Office Action Summary	Application No. 10/796,144	Applicant(s) OHASHI ET AL.	
	Examiner Alfred Joseph Wujciak III	Art Unit 3632

This is the first Office Action for the serial number 10/796,144, RESERVOIR THAT A BRACKET IS INTEGRATED WITH, filed on 3/10/04.

Fig. 5

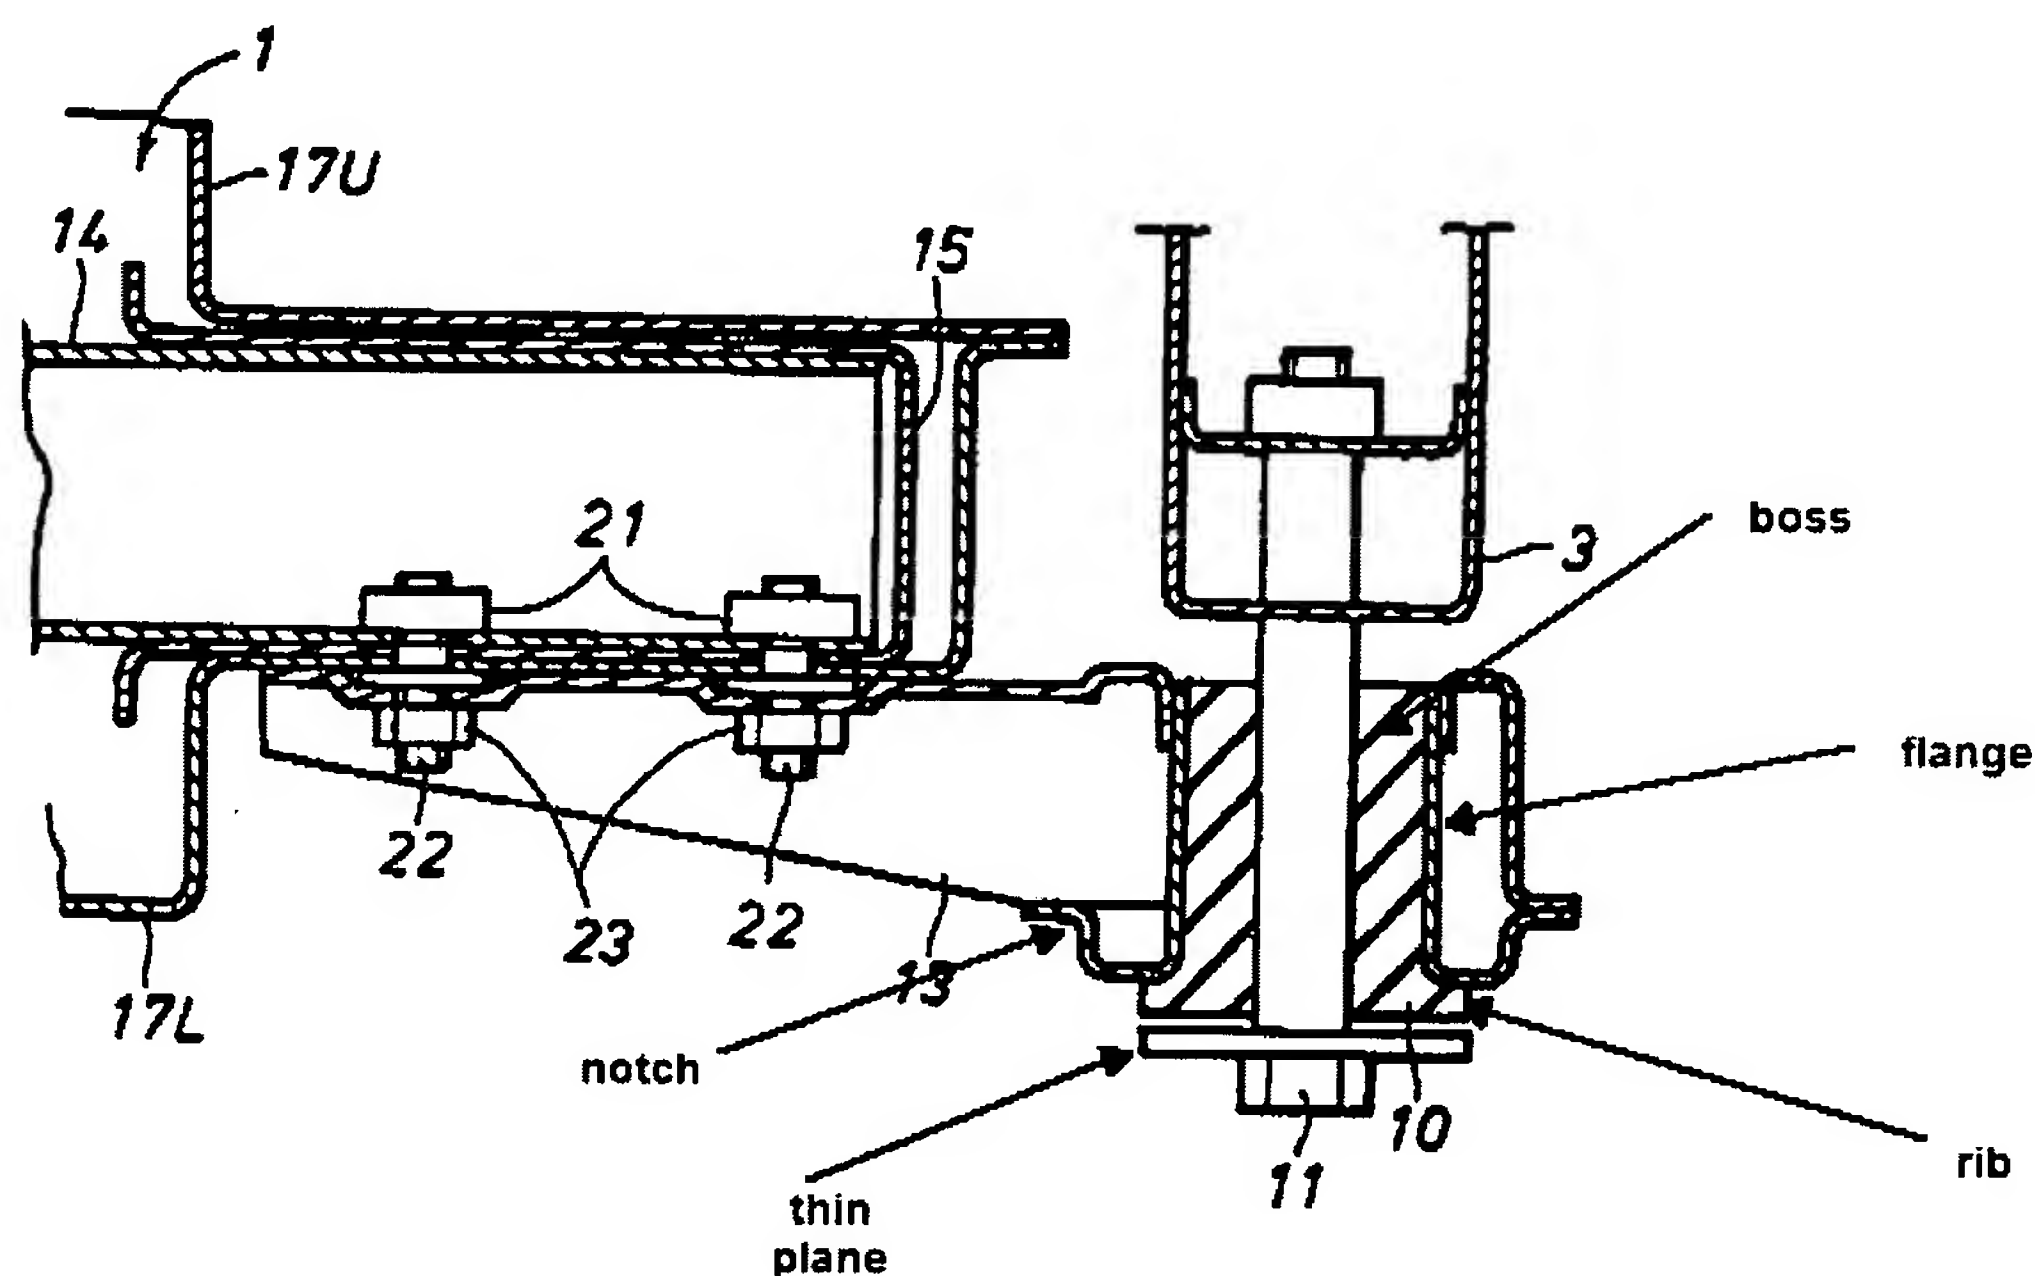
Kami teaches a reservoir comprising a tank (1), a bracket (13) integrated with the tank and an attaching portion/absorbing means (figure 5, 10-11) arranged with bracket. The attaching portion comprises a boss (10) for fixing to the vehicle (3) and flange portion arranged around the boss portion and connected to the tank. The reservoir further includes connection portion comprising notch (see drawing below). The reservoir includes first and second brackets (figure 2) having first and second attaching portions (figure 5, 10-11).

In regard to claims 3,5, and 13-14 Kami teaches the attaching portion comprising a rib portion and the first connecting portion comprising notch but fails to teach plural of rib portions connecting the boss. It would have been obvious for one of ordinary skill in the art at the time the invention was made to have added additional rib portion to the boss (transverse from existing rib) to prevent the boss from sliding down in vertical axis.

In regard to claims 4 and 6, Kami teaches the attaching portion includes a thin plane portion (adjacent to element 11) but fails to teach plural thin plane portions. It would have been obvious for one of ordinary skill in the art at the time the invention was made to have added additional thin plane portion to the attaching portion to provide additional support for retaining the boss within the flange of bracket.

Kami teaches plural of thin planes but fails to teach the thin planes are arranged between the rib portions. It would have been obvious for one of ordinary skill in the art at the time the invention was made to have modified the position and size of thin planes from top of rib to between the ribs to provide designer's preference for the location of the thin planes.
